Rio Algom Mining LLC

Re: **License SUA-1473, Docket No. 40-8905**
Proposed Modification to Environmental Monitoring Program

Rio Algom Mining LLC
License SUA-1473, Docket No. 40-8905
Proposed Modification to Environmental Monitoring Program

Rio Algom Mining LLC
License SUA-1473 Docket 40-8905
Proposed Relocation of Existing Environmental Monitoring Location - Mill Diversion

Figure 1

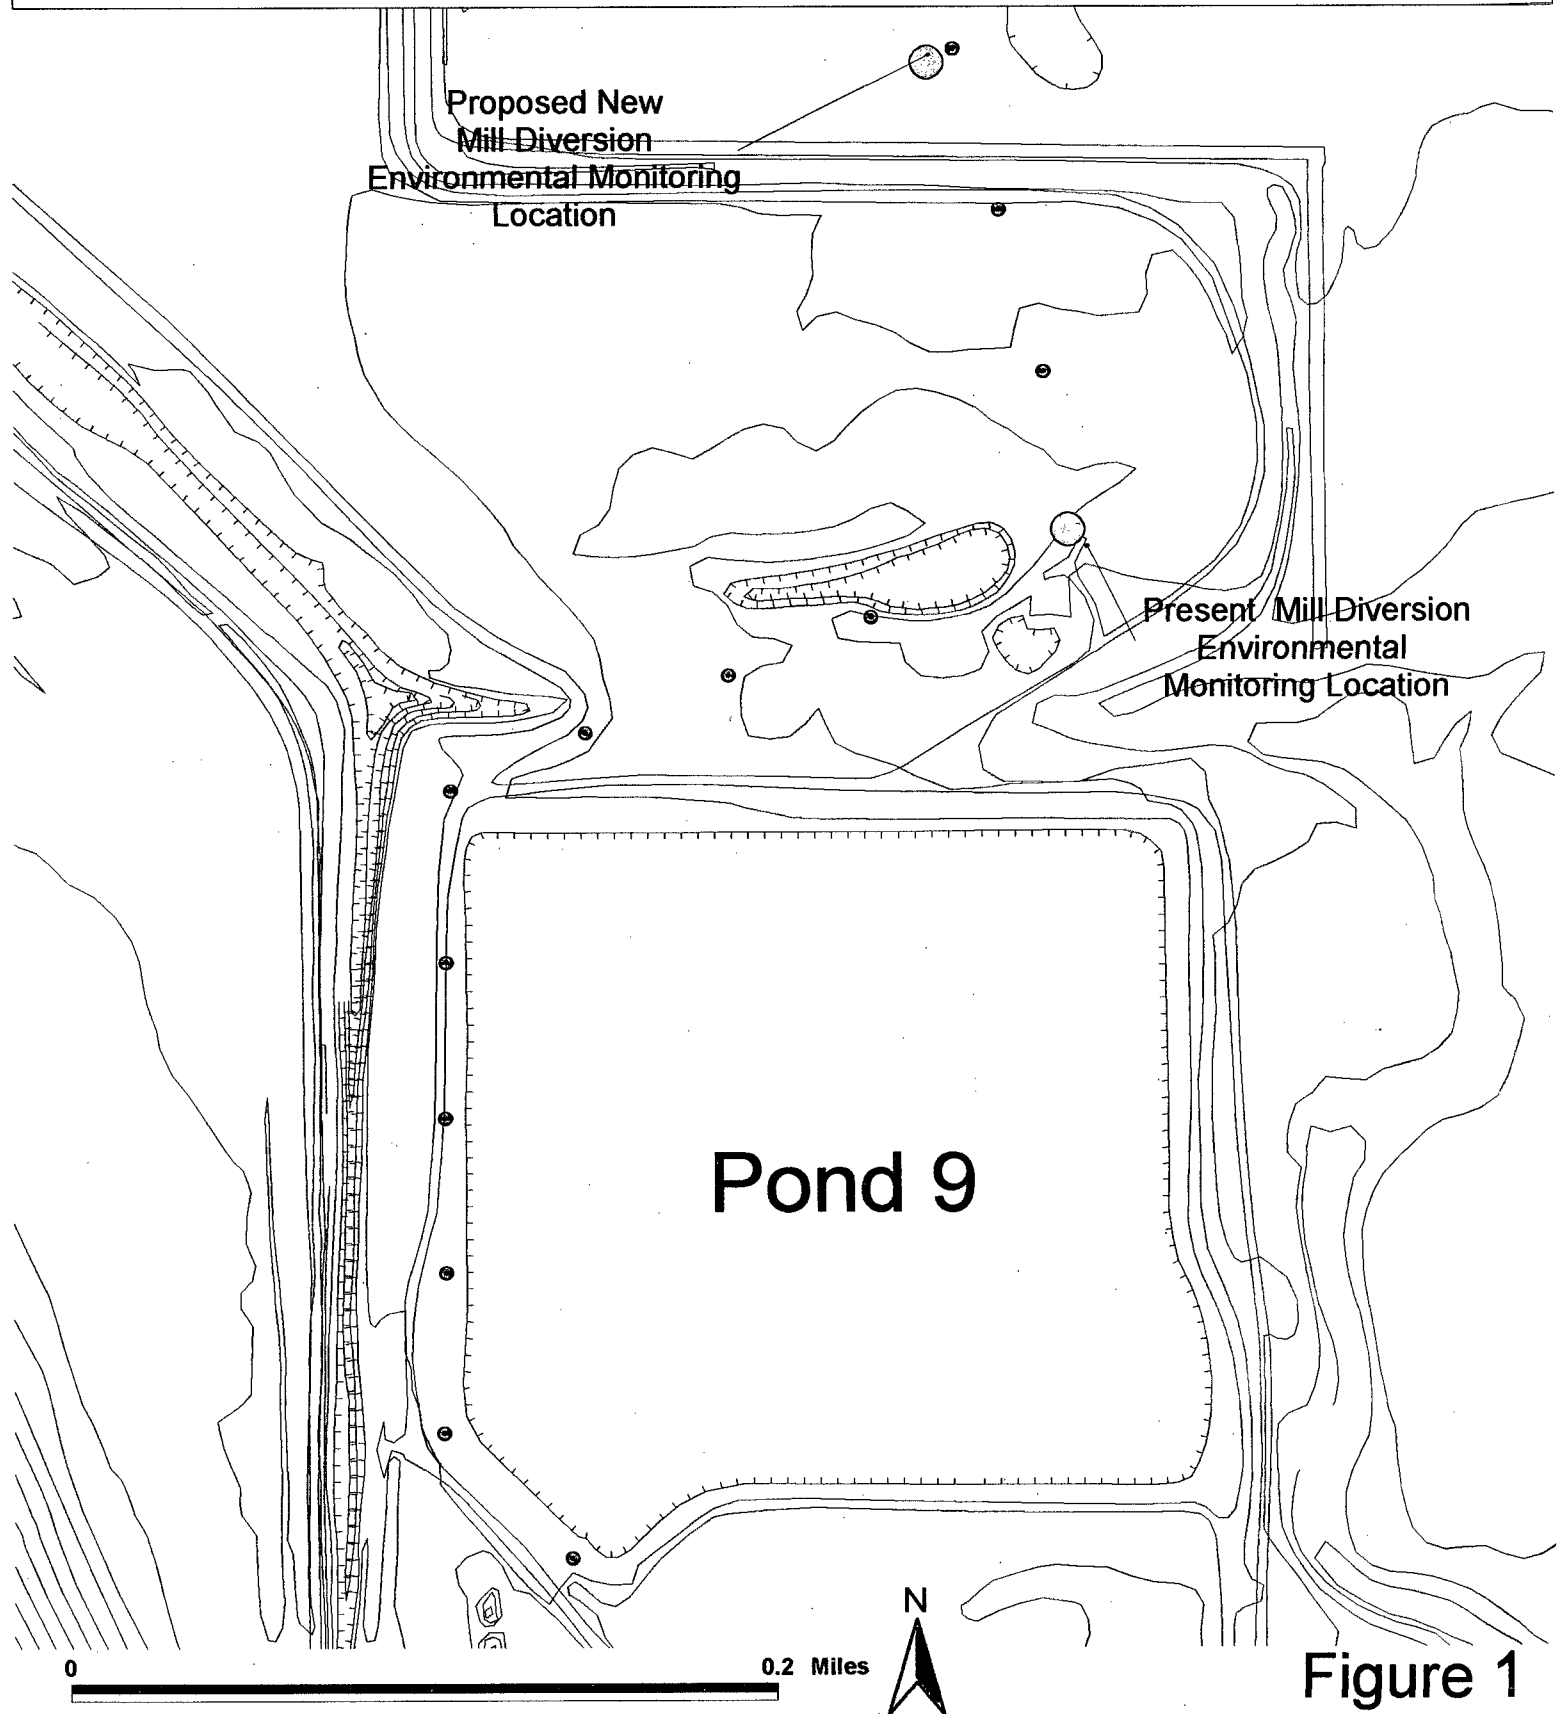
The sampling location identified as Mill Diversion is located approximately 400 feet north of Pond 9 (Figure 1). The power supply for this location is provided by a power line that was used to facilitate pumping needs associated with the groundwater corrective action program (CAP). With approval of the alternate concentration limits (ACL) for the site, reclamation and closure of the CAP related facilities, including Pond 9, is scheduled to commence in the spring 2007. This will require the removal of the powerline that feeds the Mill Diversion sampling station.

Rio Algom intends to eliminate approximately 3000 feet of the powerline. The nearest power source for the sampling station will be approximately 700 feet north of the present location (Figure 1). Rio Algom anticipates that data will be obtained from the proposed location will be similar/consistent to that obtained in the current location.
